**CITY OF PROVIDENCE**  
**BUILDING BOARD OF REVIEW**

Petition for variation or modification of the application of certain provisions of the Rhode Island State Building Code:

PROJECT :  
CONVERSION OF EXISTING 2-FAMILY DWELLING TO  
PROPOSED 3-FAMILY DWELLING  
427-429 LLOYD AVENUE  
PROVIDENCE, R.I. 02906

NOTICE OF REFUSAL  OF PERMIT APPLICATION	CITY OF PROVIDENCE DEPT OF INSPECTIONS AND STANDARDS 444 Westminster Street -Providence, RI. 02903 Joseph A. Doorley – Municipal Building		APPLICATION DATE 9/10/2025	APPLICATION NO. BLDG-25-1244
			DATE OF REFUSAL 10/30/2025	A P P E A L F E E \$440
LOCATION 427 Lloyd Ave. Providence, RI 02906		PAGE NUMBER 1 of 1		
APPLICANT Peter Casale	TITLE Applicant	ADDRESS 250 Gano St. Suite 1, Providence, RI 02906		
PROPERTY OWNER'S NAME Jessie Kerr and Alan Kerr		PROPERTY OWNER'S FULL ADDRESS 427 Lloyd Ave. Providence, RI 02906		
THE APPLICATION FOR A <b>CERTIFICATE OF OCCUPANCY</b> FOR THE ABOVE LOCATION HAS BEEN REFUSED BECAUSE THE PROVISIONS OF THE RHODE ISLAND STATE CODE HAVE NOT BEEN COMPLIED WITH IN THE FOLLOWING PARTICULARS.				
<b>SCOPE OF PERMIT:</b> For interior alteration to change use from two-family dwelling to three-family dwelling.

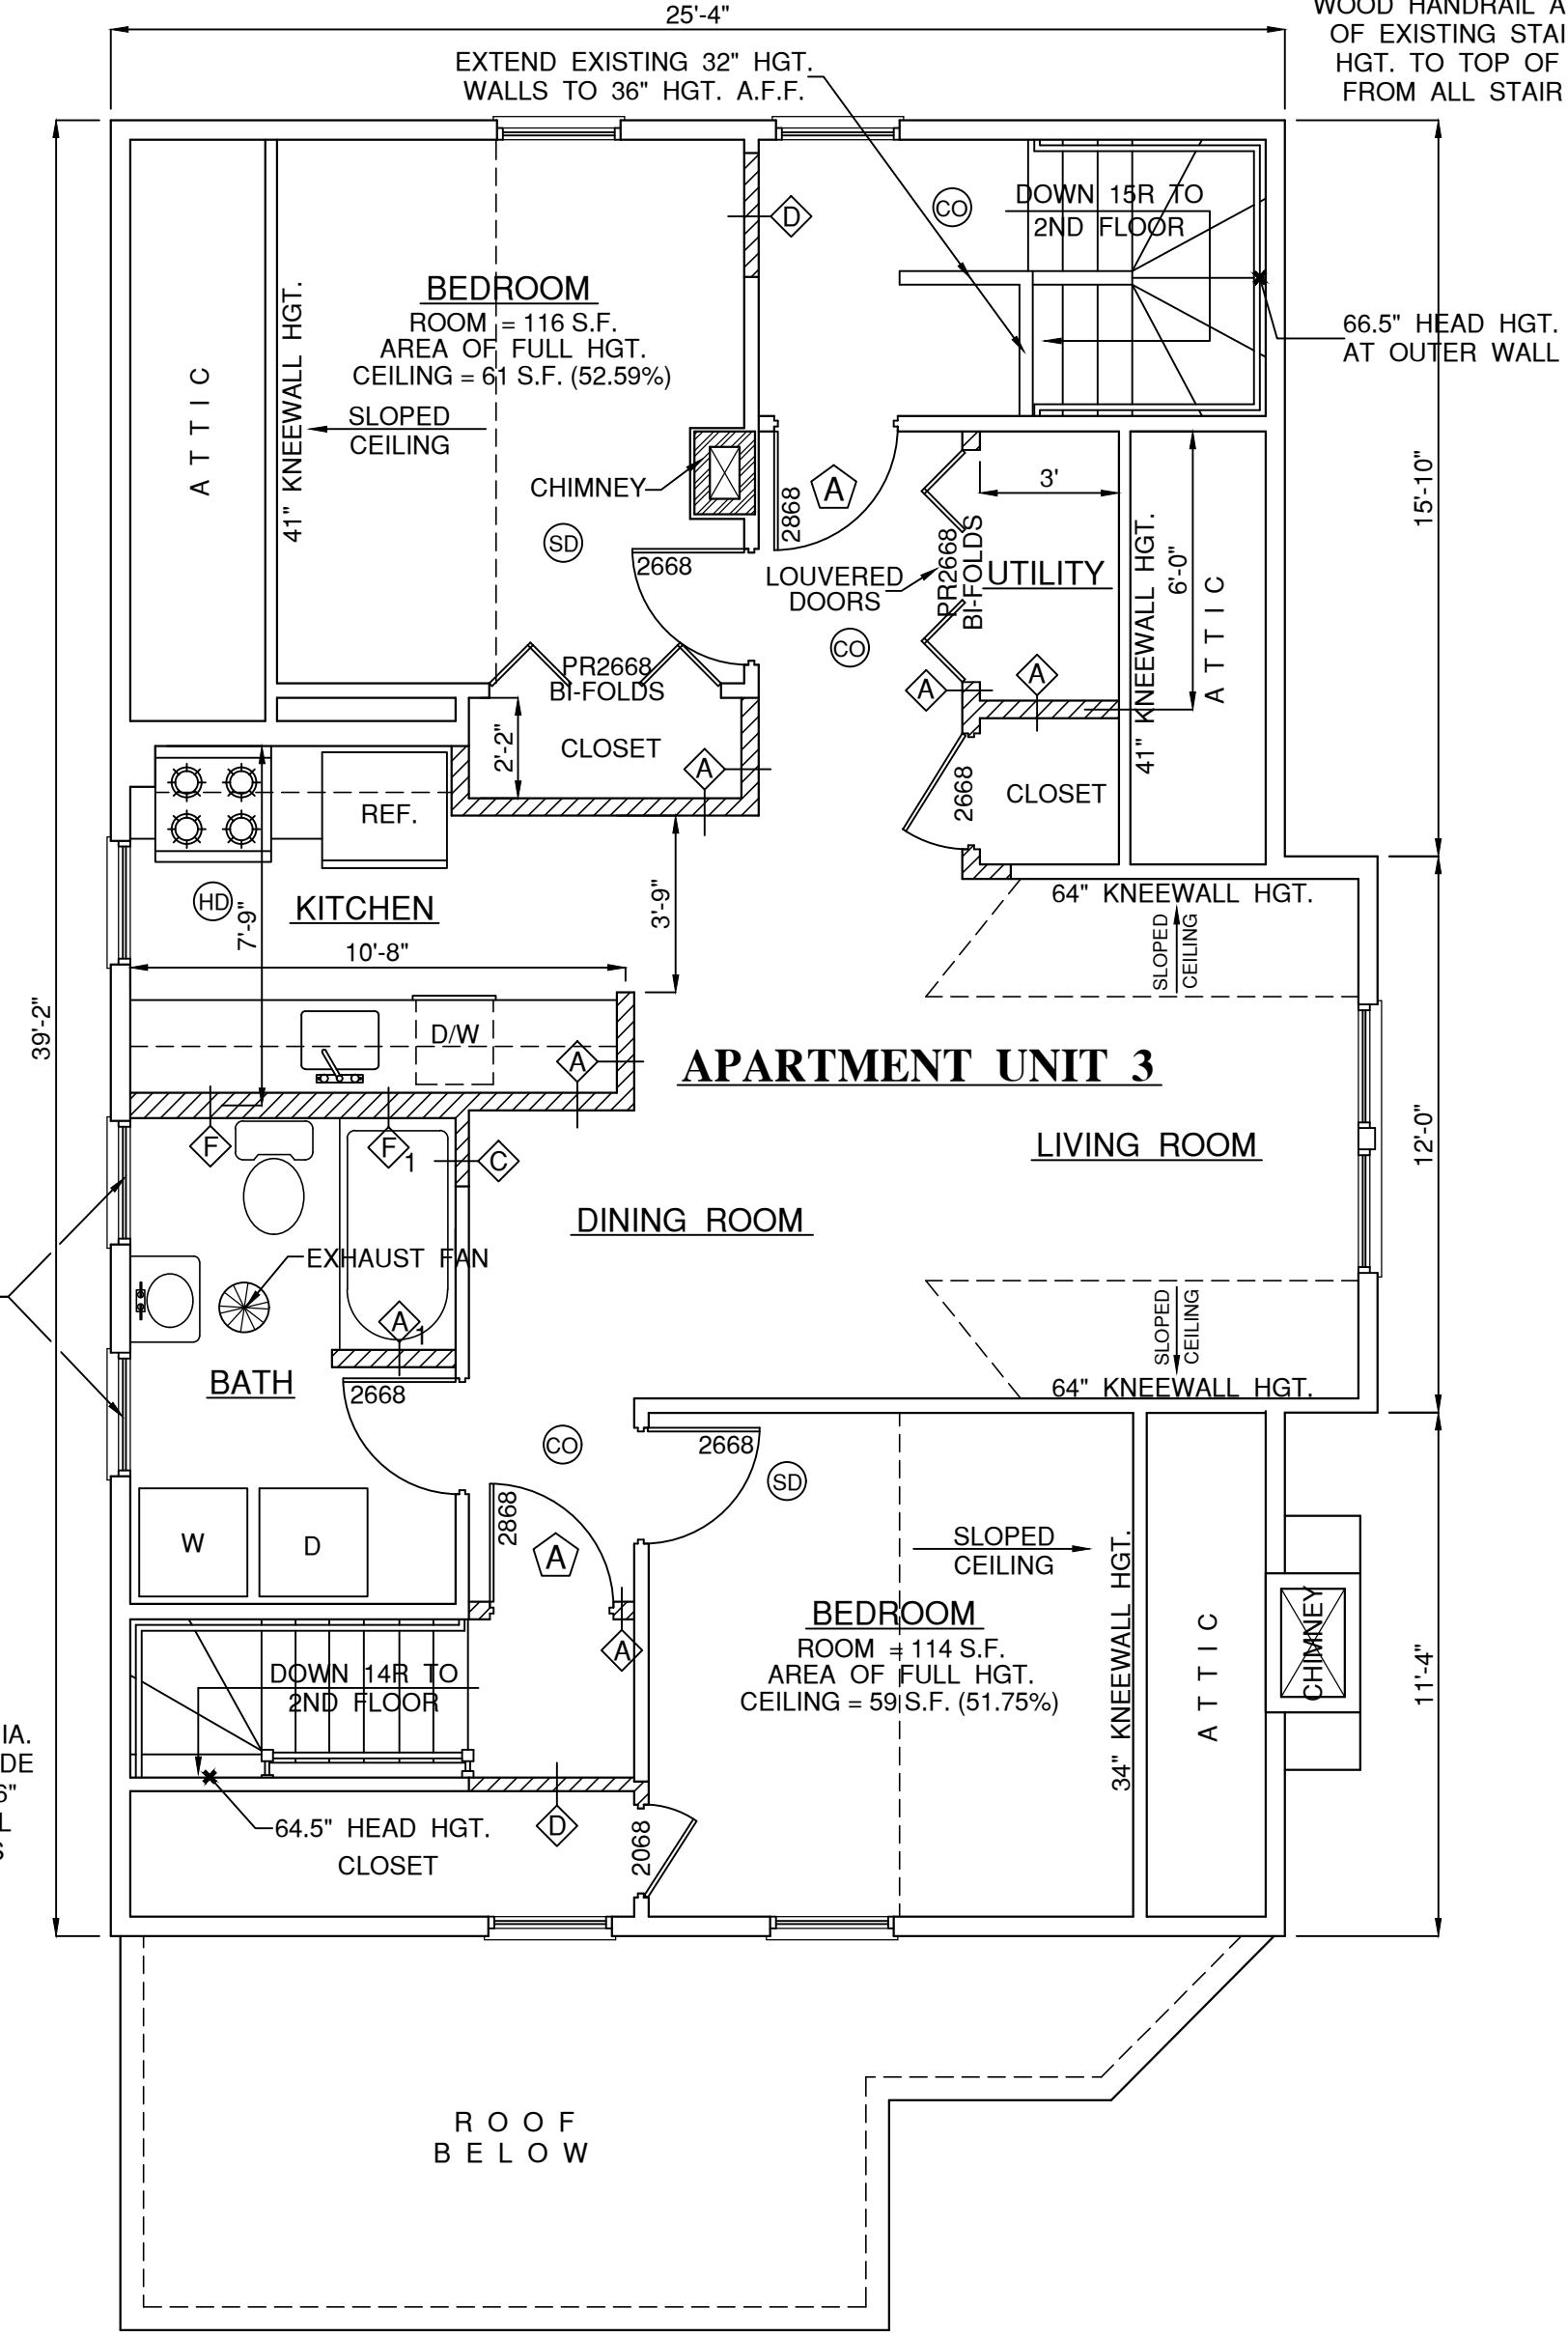
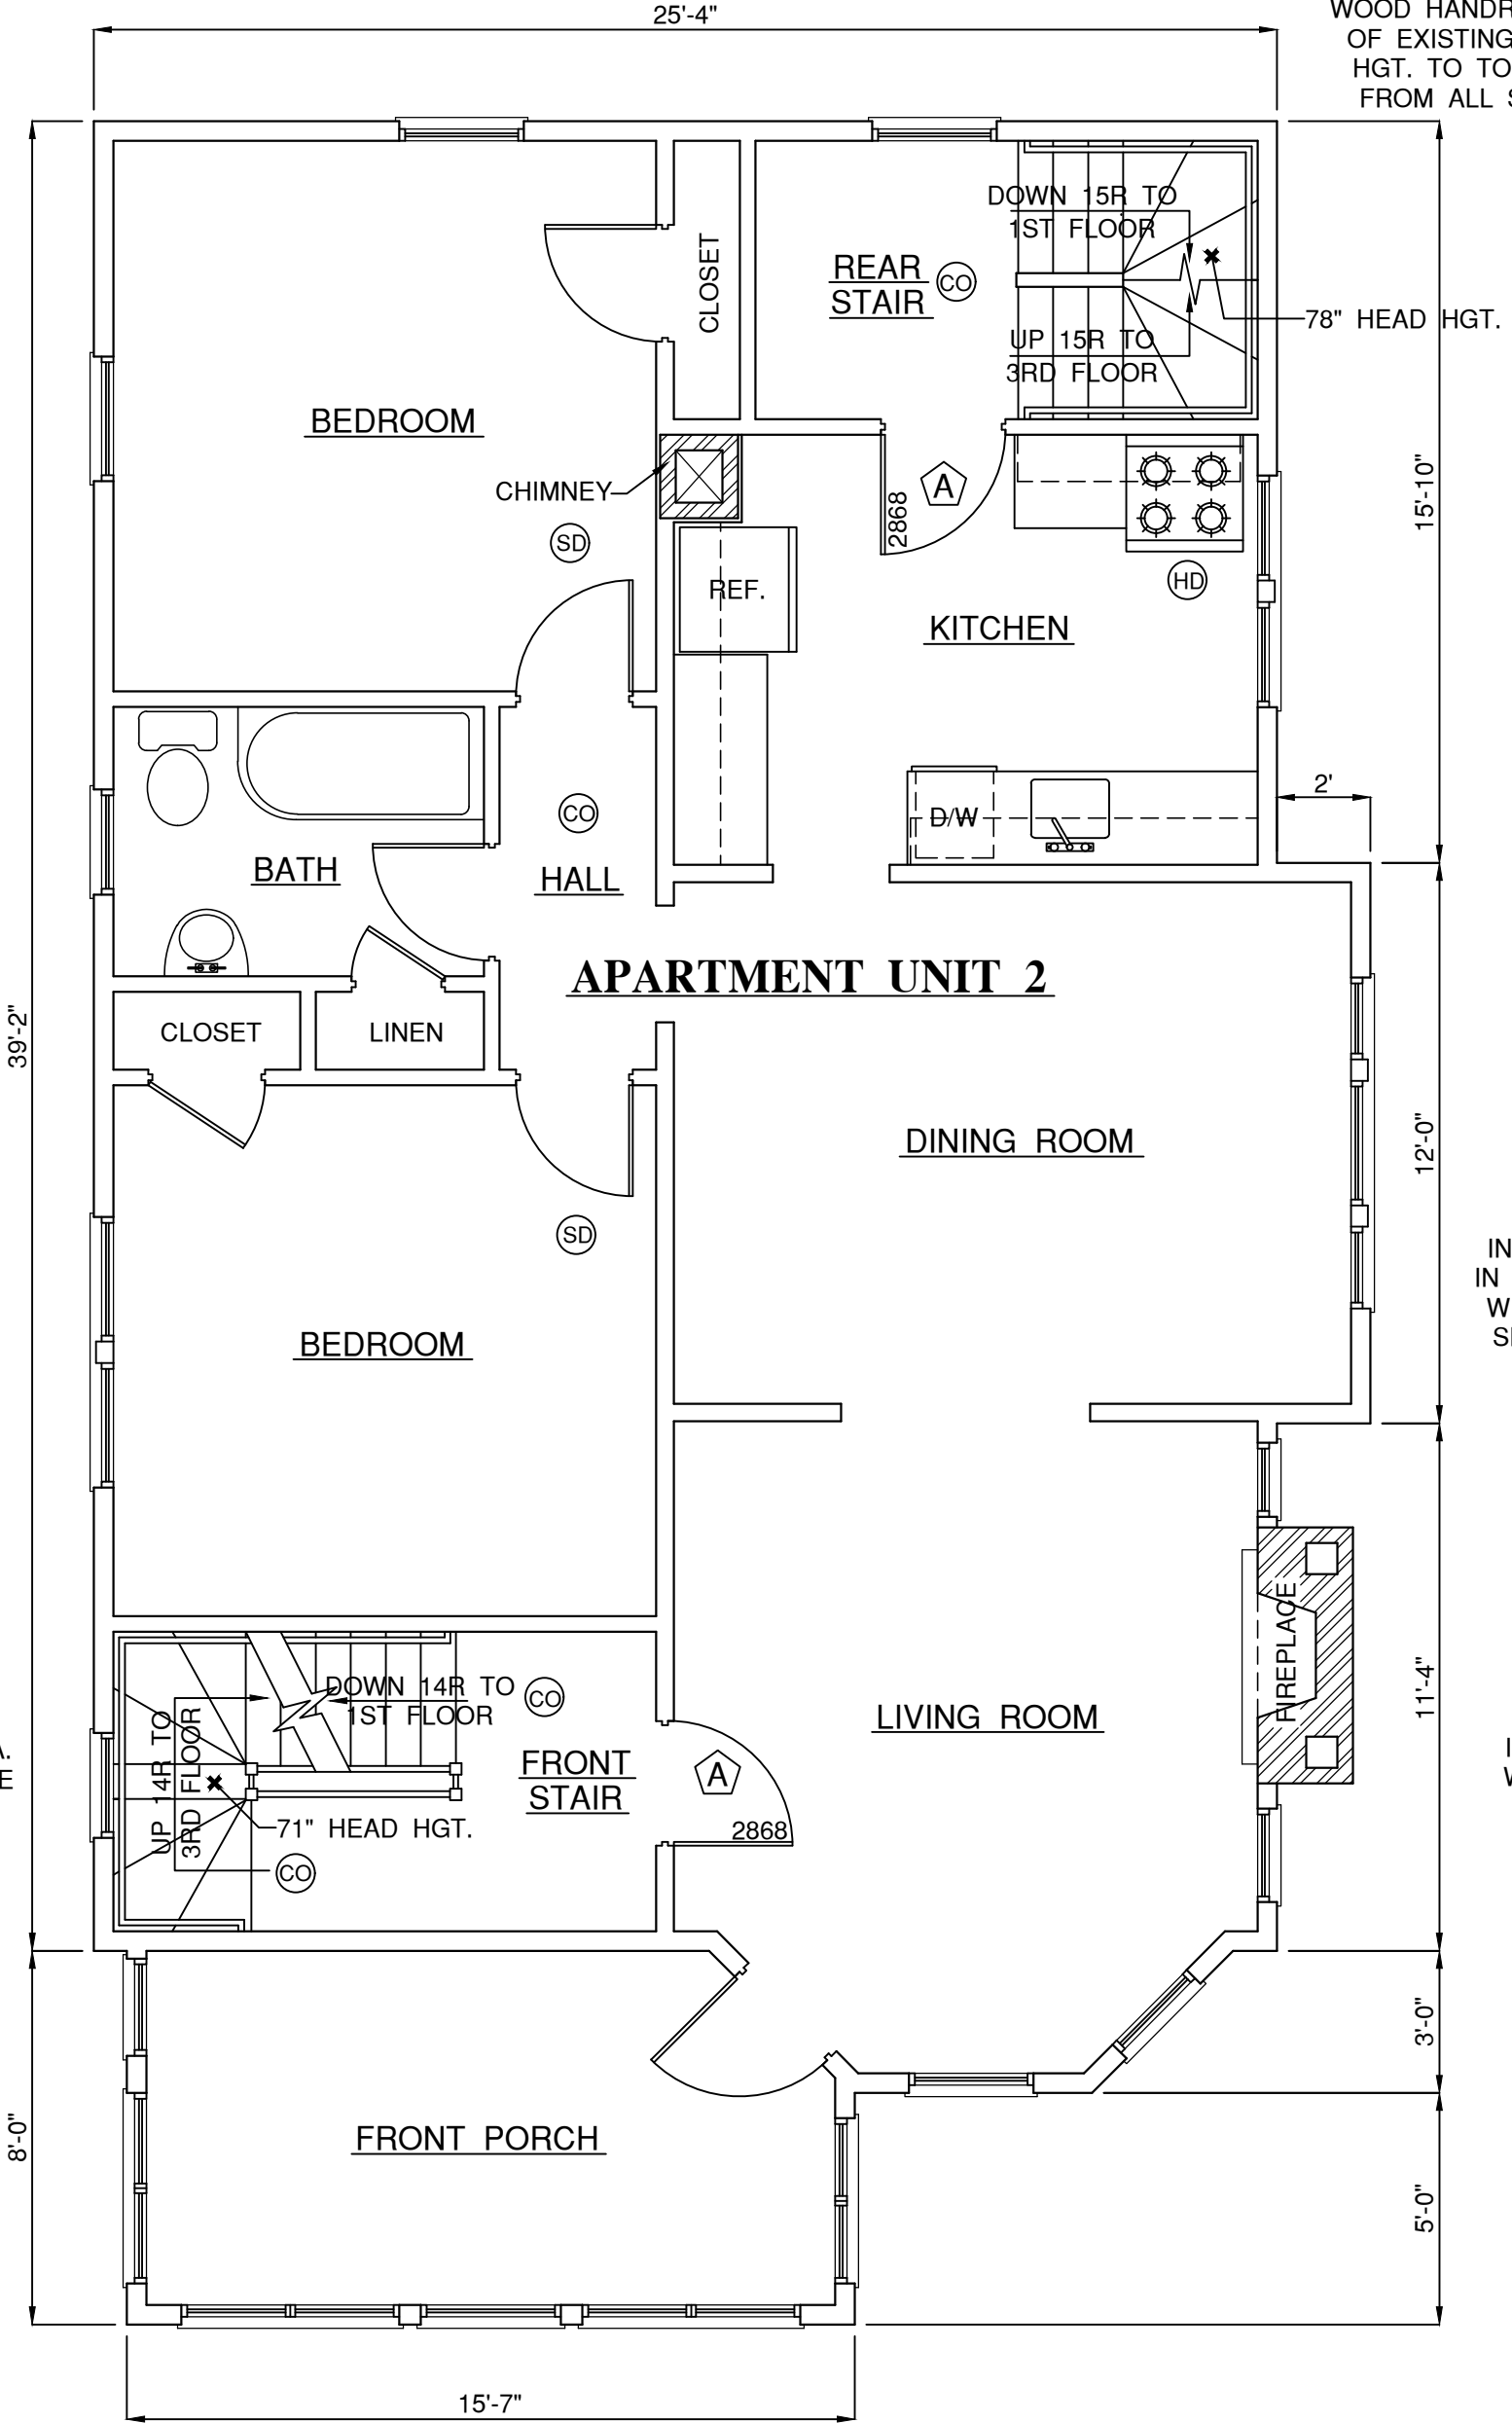
Has the proposed scope of work been completed? <input type="radio"/> Yes <input checked="" type="radio"/> No    Has a violation been noted for this property? <input type="radio"/> Yes <input checked="" type="radio"/> No				
<b>RISBC-1 Rhode Island Building Code (510-RICR-00-00-1)</b>		<b>CODE SECTIONS AND REASONS FOR REFUSAL</b>		
Section 3404.1		Alterations Except as provided by section 3401.4 or this section, alterations to any building or structure shall comply with the requirements of the code for new construction. Alterations shall be such that the existing building or structure is no less complying with the provisions of this code than the existing building or structure was prior to the alteration.		
Section 420.4		Automatic sprinkler system. Group R occupancies shall be equipped throughout with an automatic sprinkler system in accordance with Section 903.2.8.		
Section 903.2.8		Group R. An automatic sprinkler system installed in accordance with Section 903.3 shall be provided throughout all buildings with a Group R fire area.

**		Whereas, No fire suppression system is proposed.		
Section 1011.5.2		Riser height and tread depth. Stair riser heights shall be 7 inches (178 mm) maximum.

**		Whereas, the proposed risers are 8 inches.		
Section 1011.5.2		Riser height and tread depth. Rectangular tread depths shall be 11 inches (279 mm) minimum.

**		Whereas, the proposed treads are 9 inches.		
Section 1011.3		Headroom. Stairways shall have a headroom clearance of not less than 80 inches (2032 mm) measured vertically from a line connecting the edge of the nosings.

**		Whereas, the proposed headroom is 64.5/66.5 inches.
